BCA Assessment Report

ESR Westlink Stage 2 Lot 3 – MOD 6
Aldington & Abbots Road Kemps Creek

Revision 3

18 February 2025

Figure 2: Rise in Storeys Assessment

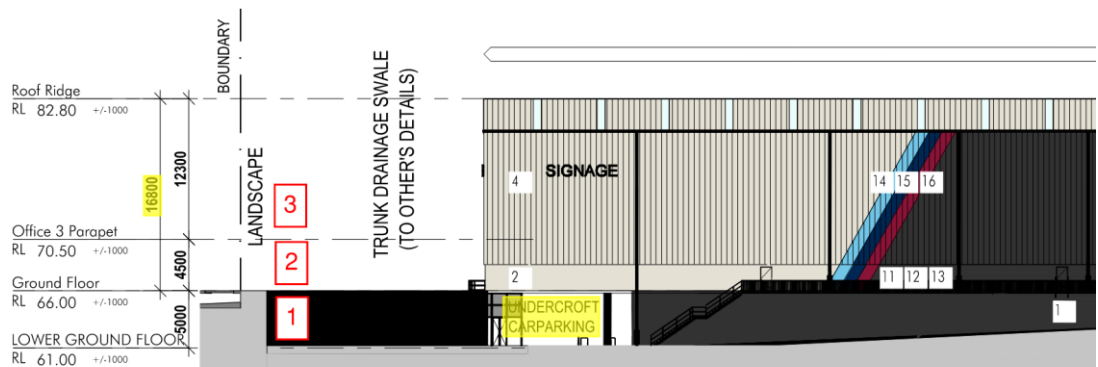
Comment: The proposed development has a rise in storeys of three (3) due to the average internal height of the warehouse building and the overhang of the warehouse above the undercroft carpark. As the warehouse has an average internal height of more than 6m and is not the only storey above ground (the underground carpark being considered 'ground level') the warehouse counts as 2 storeys as per C2D3(3)(b) – see Figure 2 below:

Figure 3: Perimeter Vehicular Access Markup

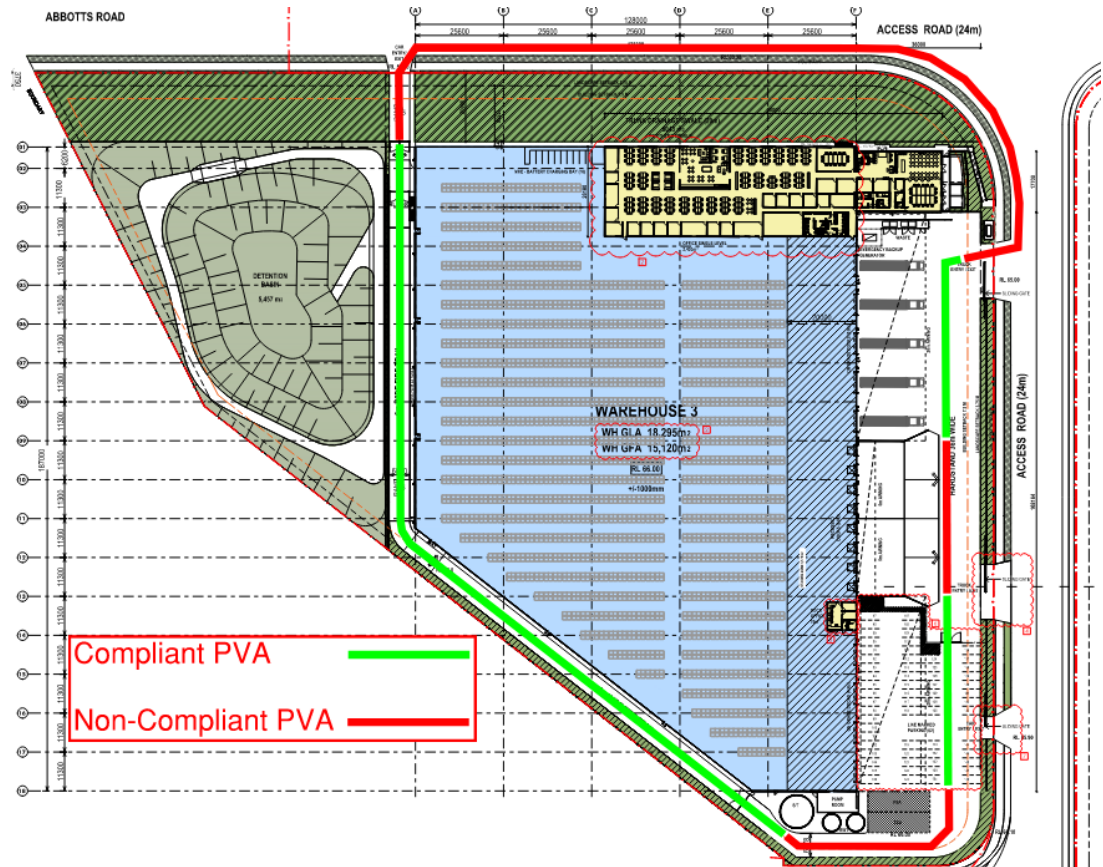
C3D4	<p>Large Isolated Buildings: A Large Isolated Building that contains Class 5, 6, 7, 8 or 9 parts, is required to be—</p> <ul style="list-style-type: none"> + Protected throughout with a sprinkler system complying with Specification 17; and + Provided with a perimeter vehicular access complying with C3D5(2). <p>Comment: The proposed warehouse building is required to be sprinkler protected and provided with a 6m wide perimeter vehicular accessway in accordance with Clause C3D5(2) throughout. Refer to comments under C3D5 below.</p>
C3D5	<p>Requirements for Open Spaces and Vehicular Access: Open space and vehicular access required by C3D4 must comply with the requirements of sub-clauses (a) & (b) of this Part whereby they must be 6m wide within 18m of the external walls of the building and of a suitable bearing capacity and unobstructed height to permit the operation and passage of FRNSW vehicles.</p> <p>Comment: The proposed warehouse building complies with the provisions of C3D5 except for the areas shown in red and orange on the mark-up overleaf. These non-compliances will be required to be addressed as a performance solution by the Fire Safety Engineer to demonstrate compliance with C1P9:</p> <ul style="list-style-type: none"> + Perimeter Vehicular access is greater than 18m along the northern side of the building as well as around the main office and the recessed loading docs on the Eastern hardstand.

Note 1: Any proposed gates are to achieve no less than 6m unobstructed width or the reduced width will need to be included in the above Performance Solution.

Note 3: The Fire Engineered Performance Solution must take into consideration and detail the proposed security access to the site and how this may impact on FRNSW vehicular access.

Figure 5 – Pedestrian Ramp from Undercroft Carpark

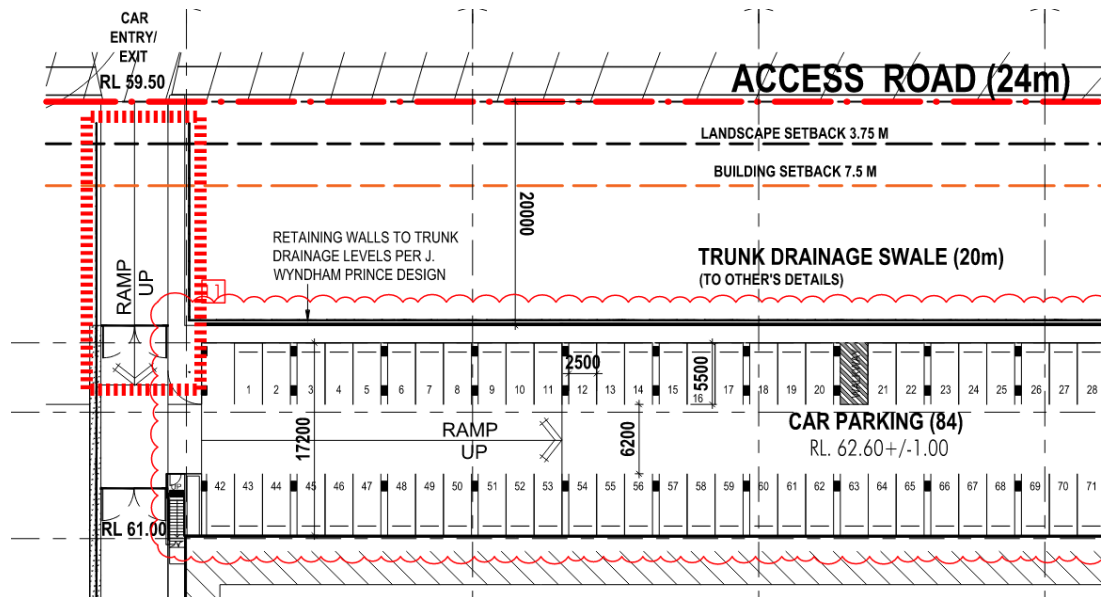
Comment: Details are to be provided regarding the grades and design of the pedestrian ramp from the undercroft carpark to the street.

Figure 6 – Carpark Egress Gate

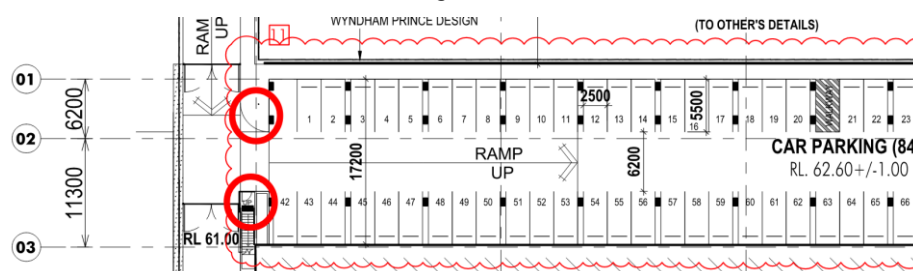
Note: The proposed pedestrian gates to the carpark is also to be provided with compliant door hardware from the inside in the direction of egress.

Figure 7 – Non-compliant office circulation space

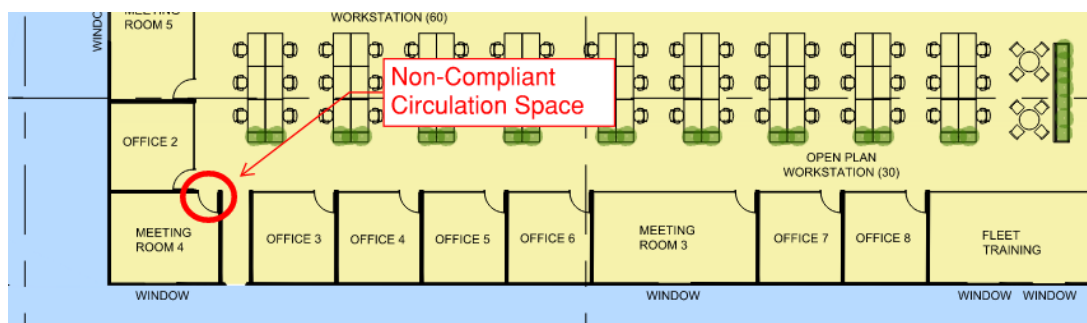
Note: Architect to review non-compliant circulation space in the office area to Meeting Room 4 and Office 2.
